NPCC Request for Criteria Clarification

Request for a Clarification of Criteria
Date submitted: December 1, 2017 Date revised version submitted: n/a
Contact information for person requesting the clarification:
Name: Alan Adamson
Organization: New York State Reliability Council (NYSRC) Reliability Rules Subcommittee
Telephone: 352-989-4653
E-mail: aadamson@nycap.rr.com
Identify the Directory that contains the Criteria requiring clarification:
Directory Number: Directory 1
Directory Title: Design and Operation of the Bulk Power System

Figure 1

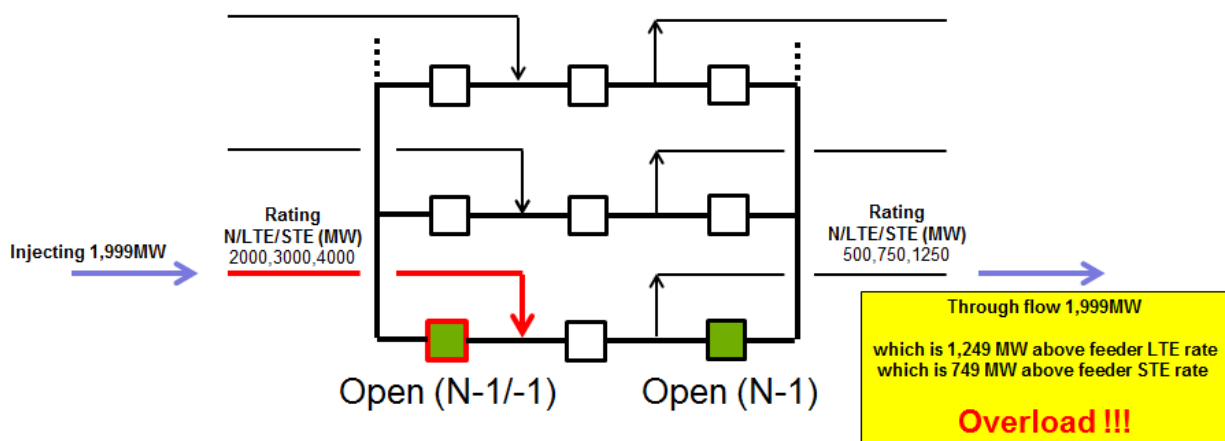
Under such N-1/-1 events, a high capacity injection (ex.: AC transmission, HVDC, or a generating unit) can be isolated onto a low rated transmission circuit (possibly loading it above its LTE or even its STE rate). Please see Figure 1 below:

1. Why does NPCC Directory 1 omit N-1/-1 event such as open breaker followed by an open breaker?

A possible solution to the identified scenario above (Figure 1) could be to open the middle breaker as a "system adjustment" within 30 minutes before the second contingency (in effect tripping the low rated transmission circuit). This action would eliminate the postulated overload illustrated in Figure 1.

2. Does NPCC Directory 1 postulate that the opening up of a circuit breaker falls within the definition of a "system adjustment"?
